L-Line Cargo > 360
A-Line Acterra
Service Bulletin

Sterling Service Bulletin, July 2006 Page 1

Fig. 1, Grille Alignment/Misalignment

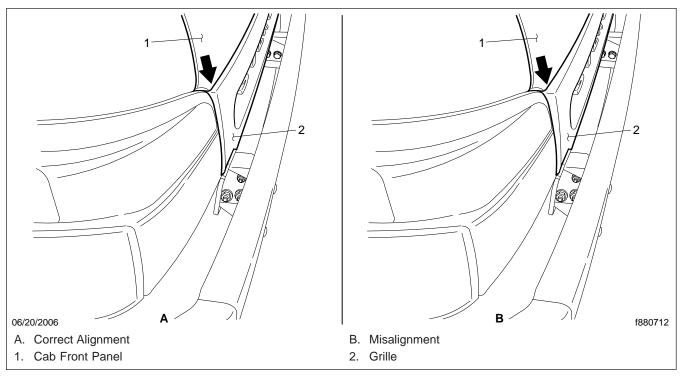
The five clips used to fasten the upper portion of the grille to the cab may not hold with enough force to prevent the grille from loosening under certain conditions. In such cases, inspect the grille for signs of misalignment, and, if found, replace the five clips with new bird-cage clips, p/n 23–12848–000 (available at the PDCs).

Inspect the upper edge of the grille where it meets the inboard end of the headlight lens. The grille should align closely with the lower edge of the cab front panel. If the outboard ends of the grille protrude forward as shown in **Fig. 1**, remove the grille and replace the five clips on the upper edge.

- 1. Set the parking brake and chock the front tires.
- 2. Remove the grille from the cab.
- 3. Remove and discard the five clips along the upper edge of the grille. See Fig. 2.
- 4. Cut off the vertical portion from each end of the foam surround as shown in Fig. 3.
- 5. Install five new bird-cage clips, p/n 23-12848-000, on the upper edge of the grille.
- 6. Install the grille on the cab.
- 7. Remove the chocks from the front tires.
